Date: 10/25/2022
RFP No: 2022-084
Commodity: Cameron Park Zoo Education Center & Vet Hospital
Purchasing Agent: Mr. Kasey Gamblin

Addendum No: 1

Addendum #1

Project Name: Cameron Park Zoo: Education Center & Vet Hospital

OVERALL FLOOR
PLAN - EDUCATION
CENTER

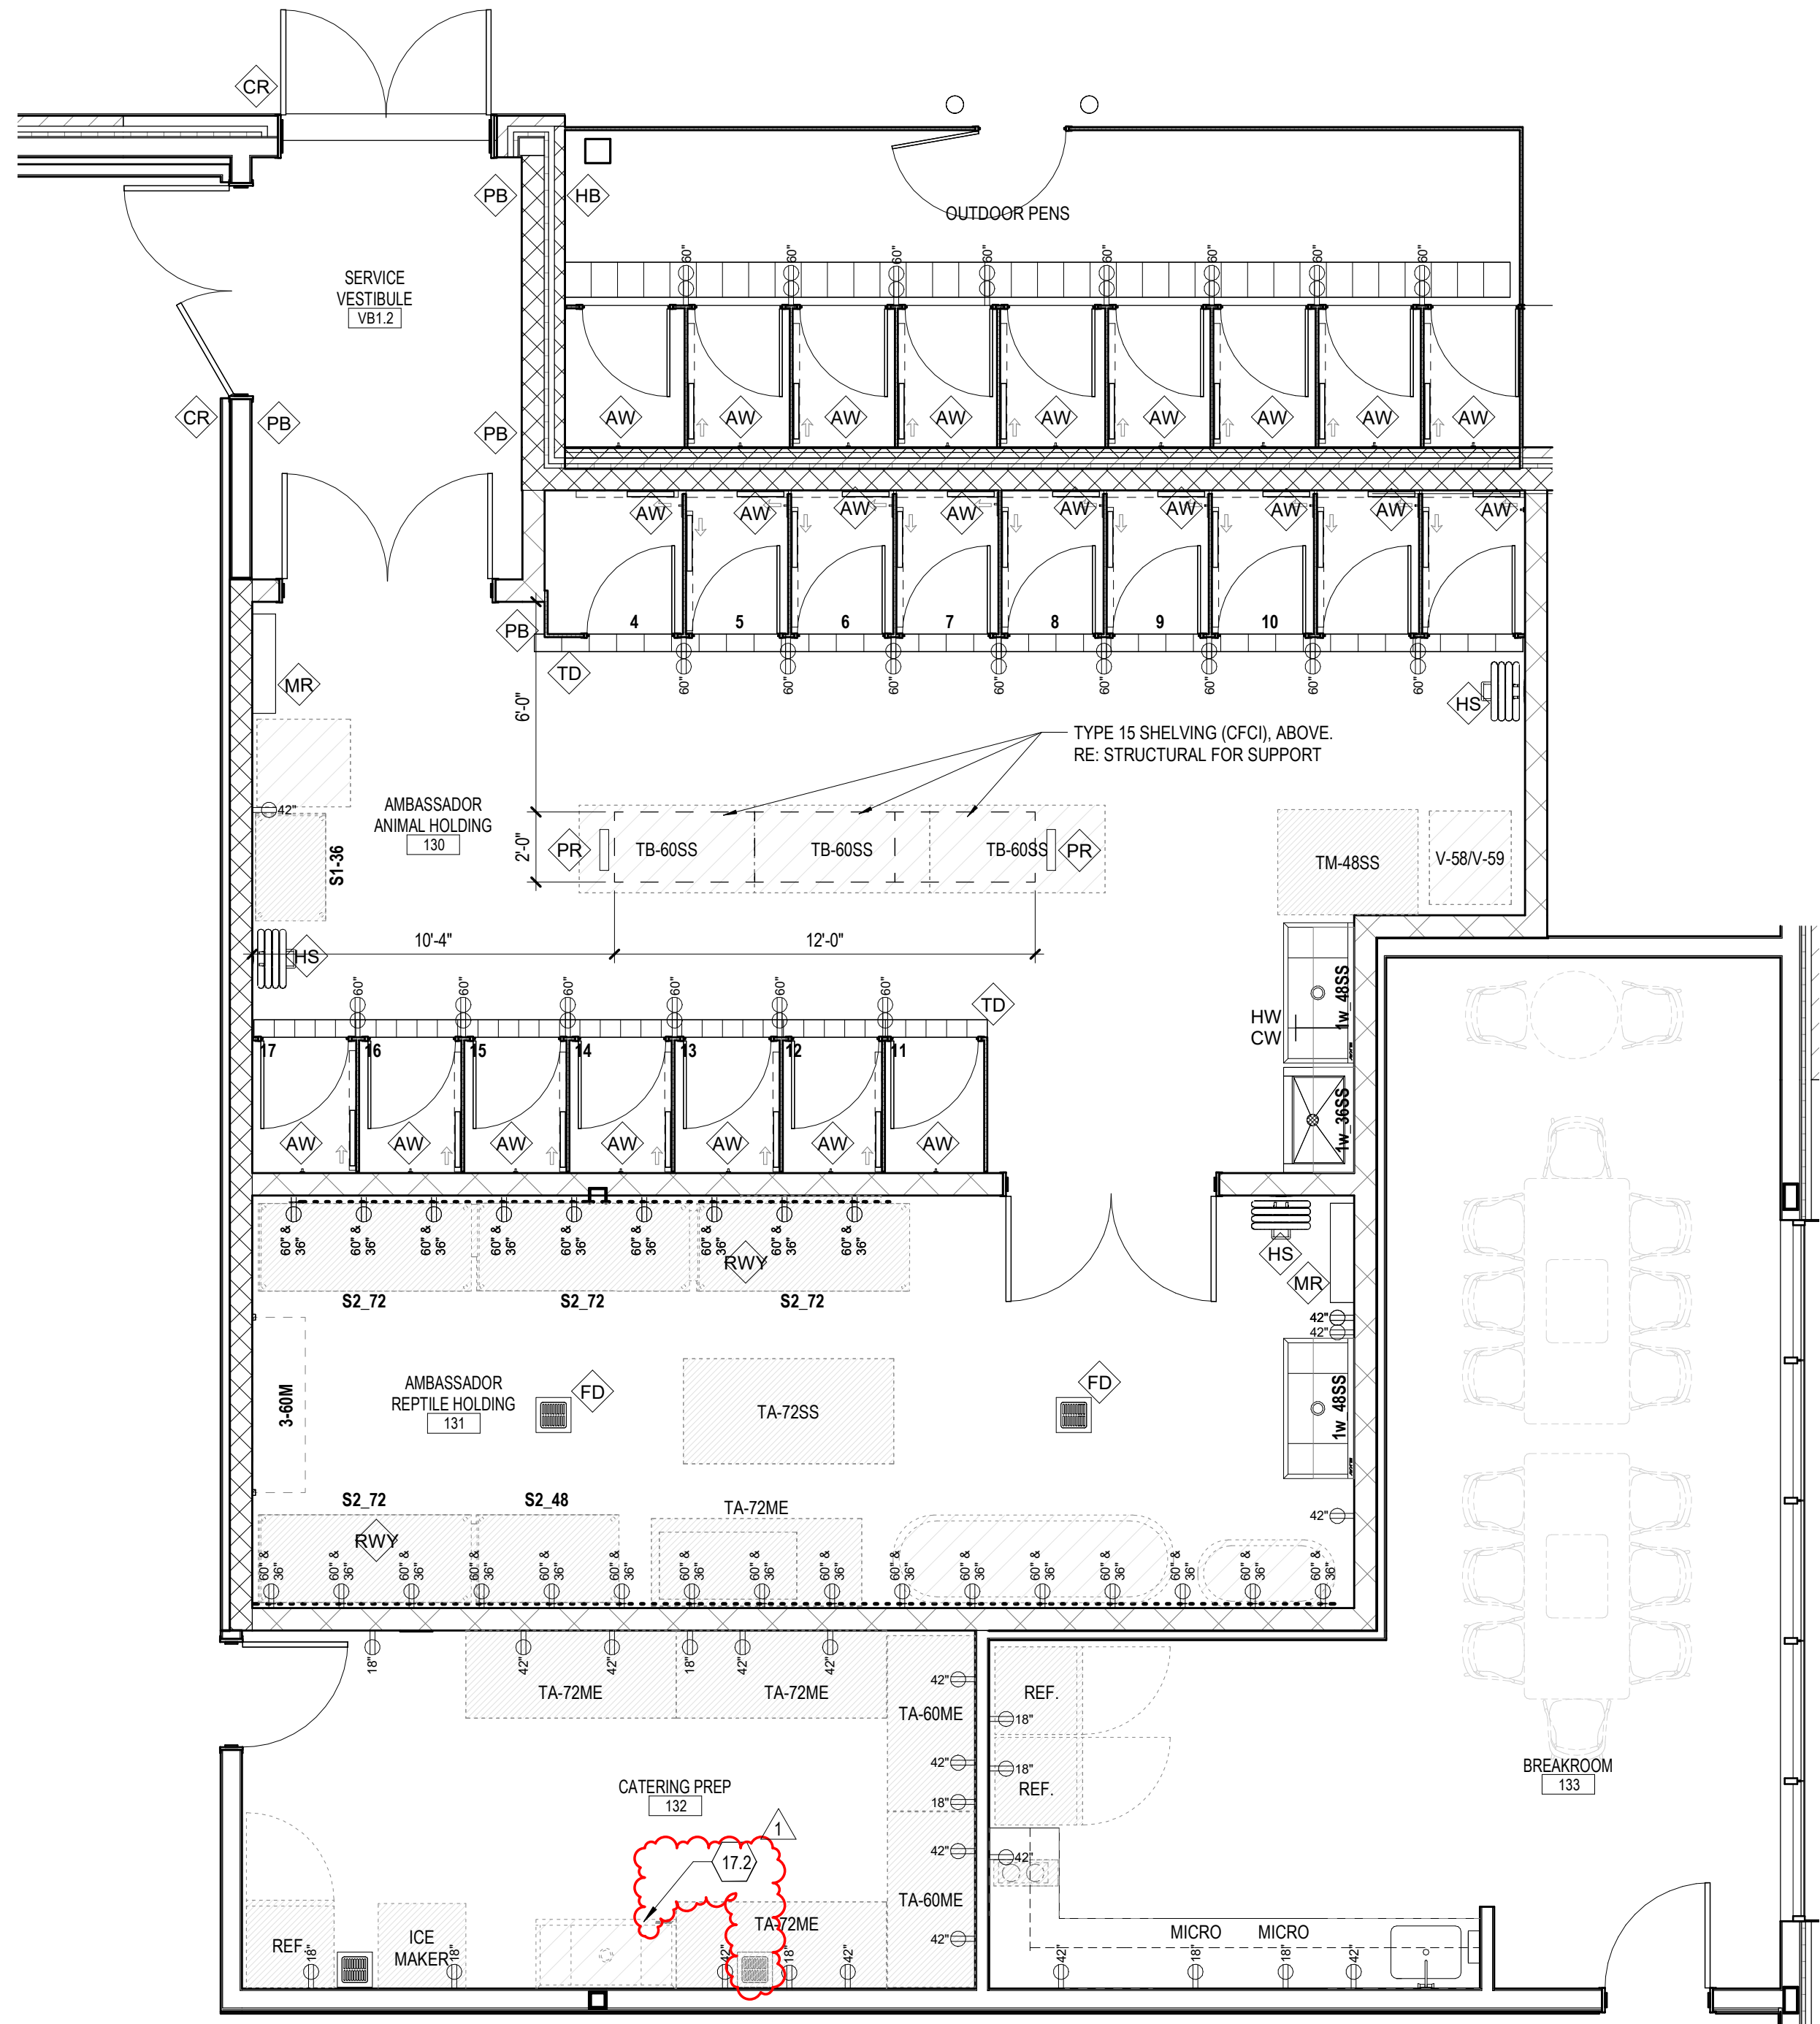
A10-01: Clarification provided for catering prep 132 sink responsibility and grease interceptor requirements.

- <<< Indicates Sheet Keynote on Plan
 FP-1 UTILITY SINK TO BE OF-01. BELOW SINK GREASE INTERCEPTOR TO BE PROVIDED AT TIME OF SINK INSTALLATION AS REQUIRED. GREASE INTERCEPTOR TO BE OF-01. REFER TO PLUMBING FOR DETAILS.

S60-10

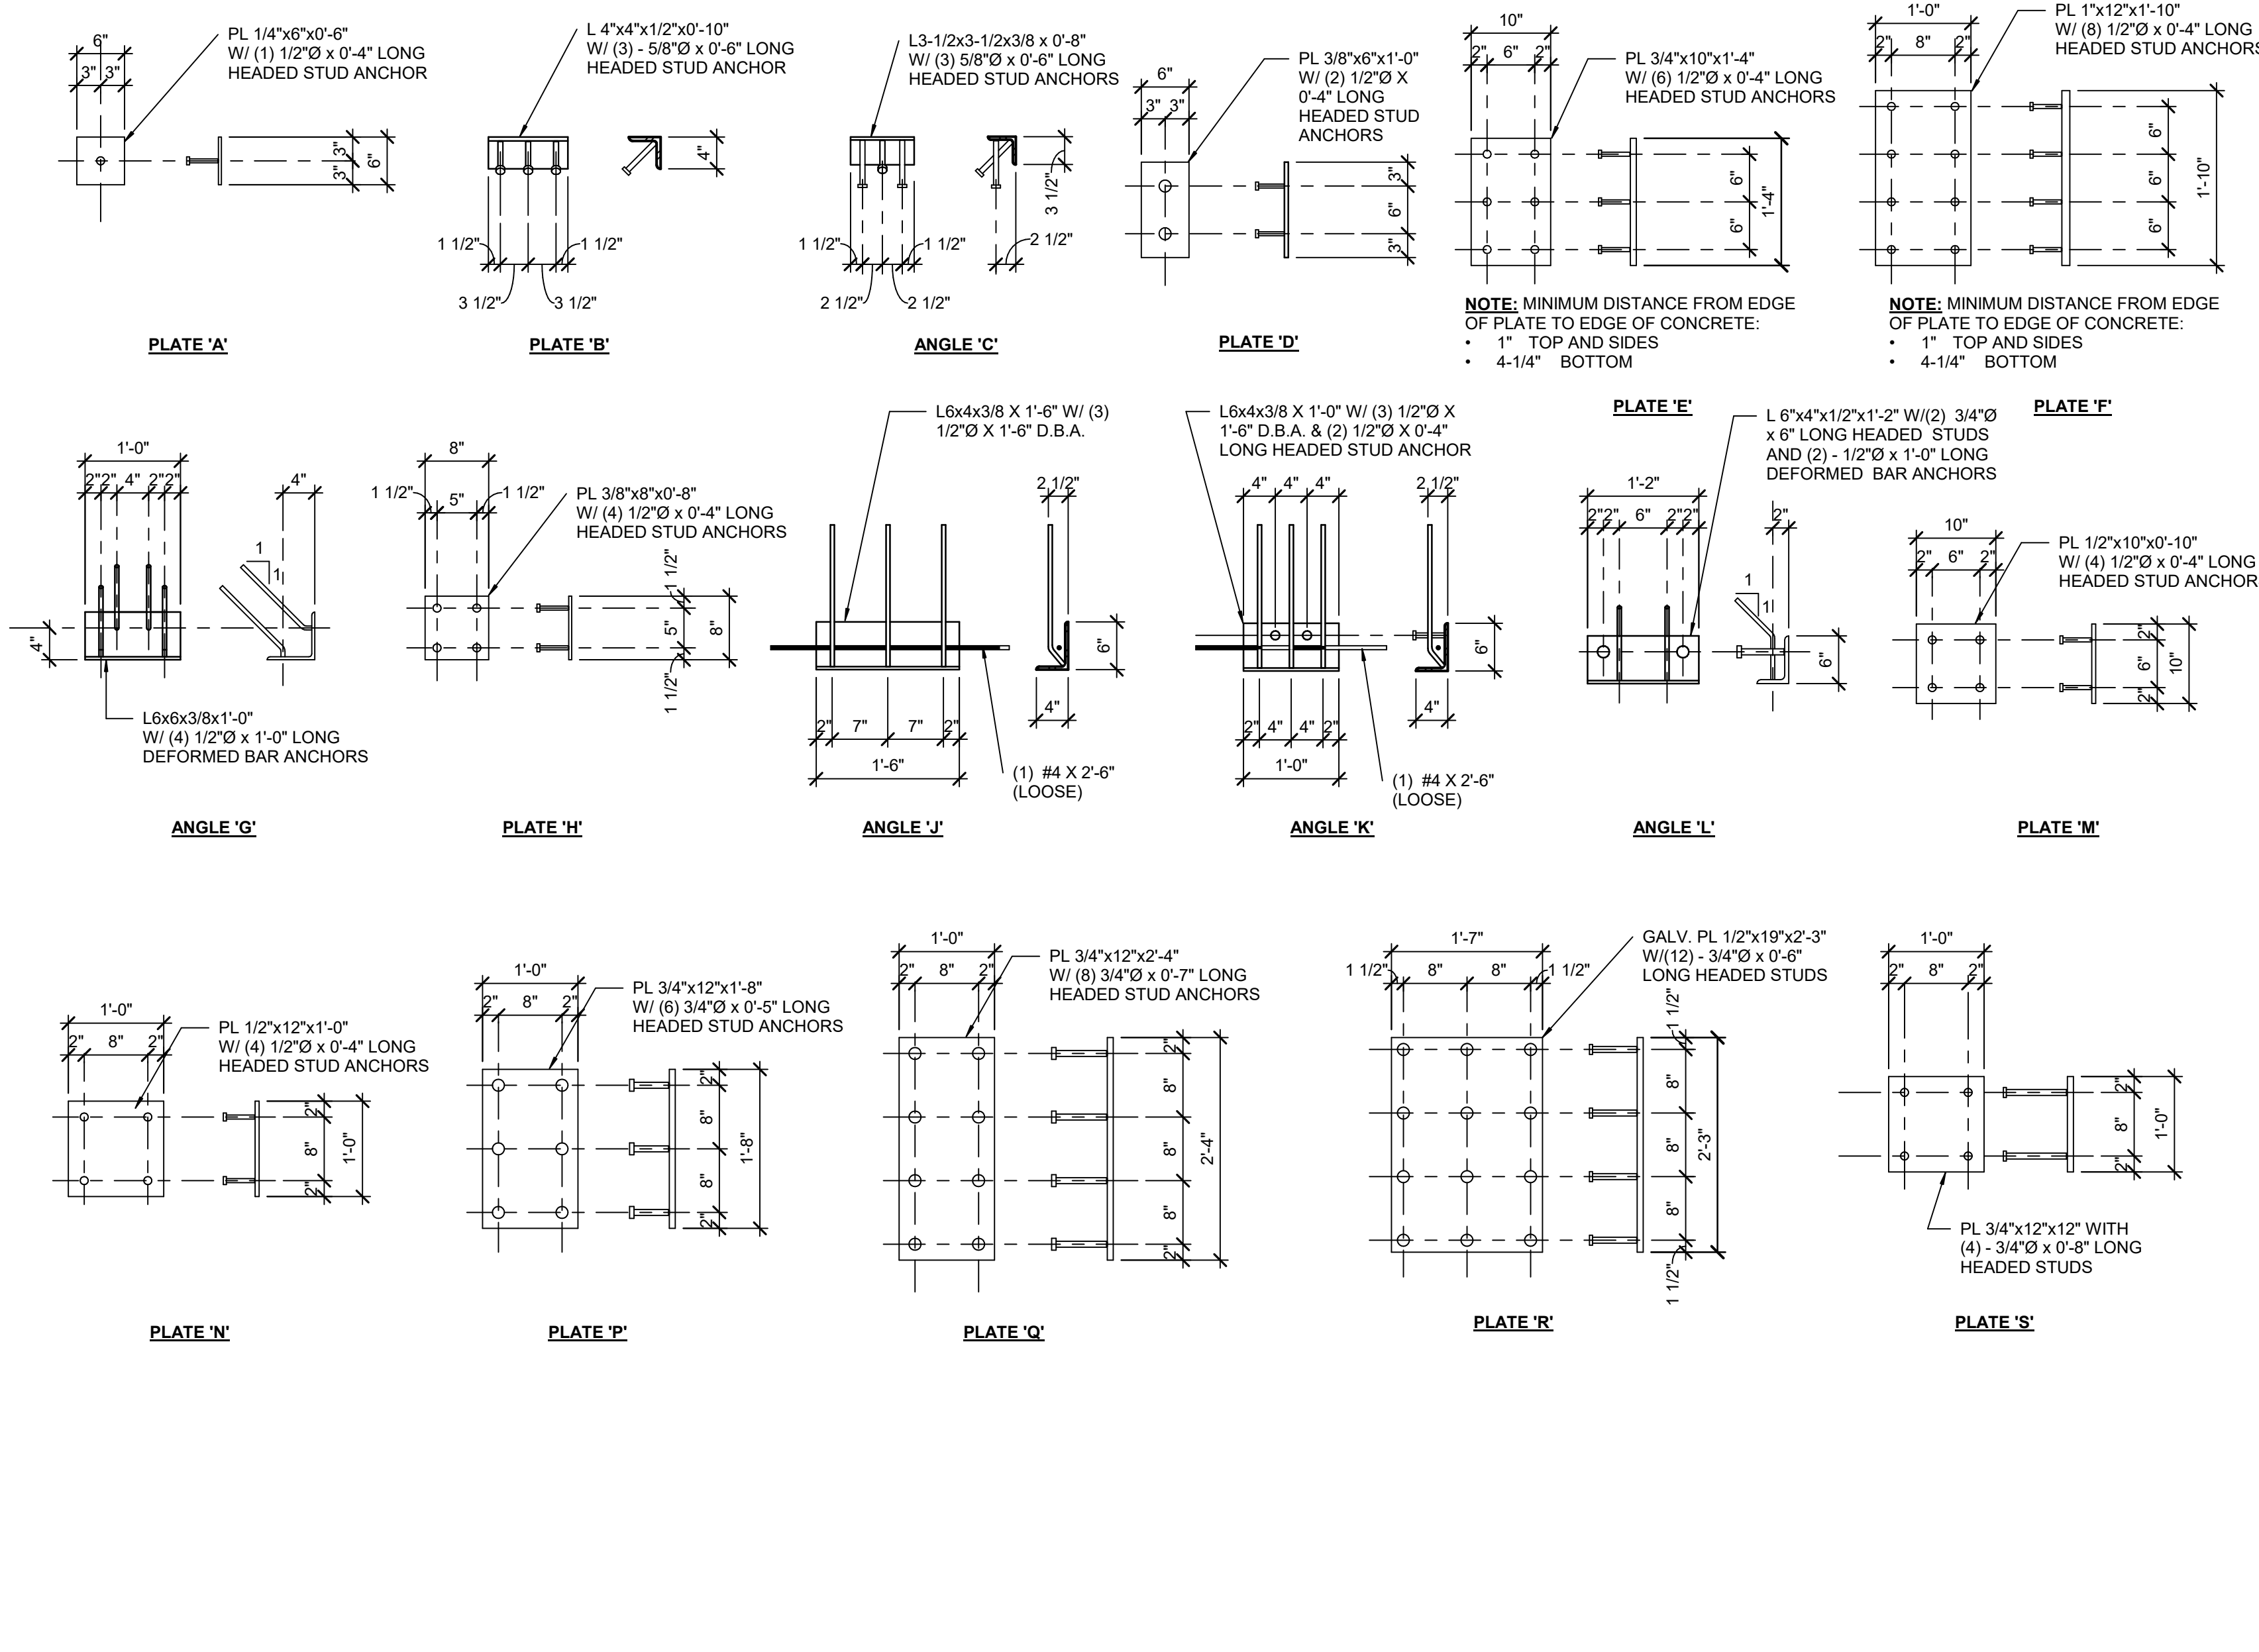
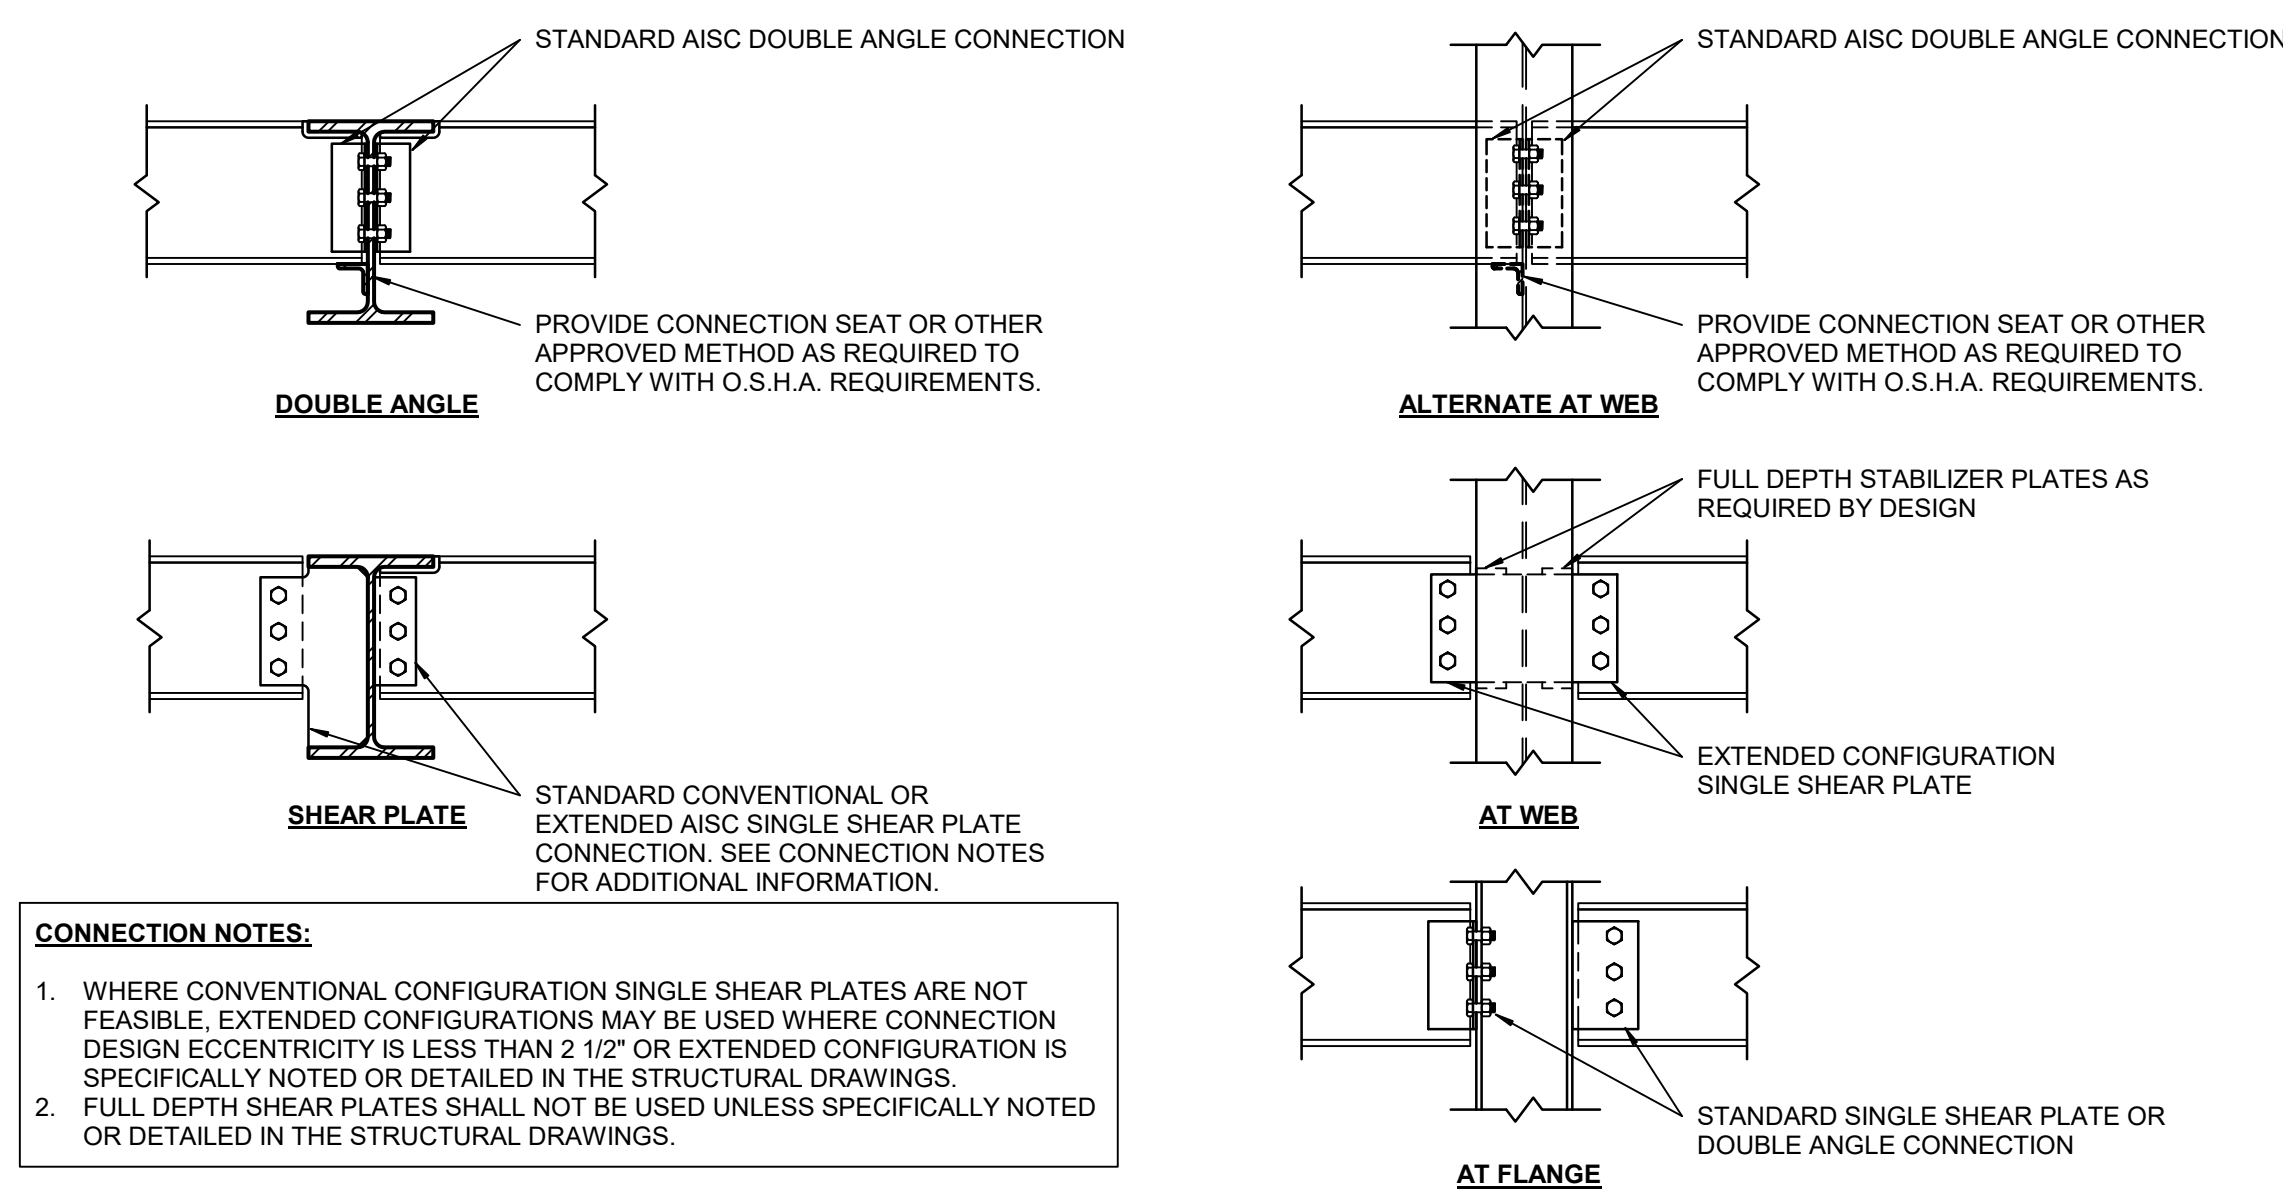
S60-10: Clarification provided for restroom countertop support
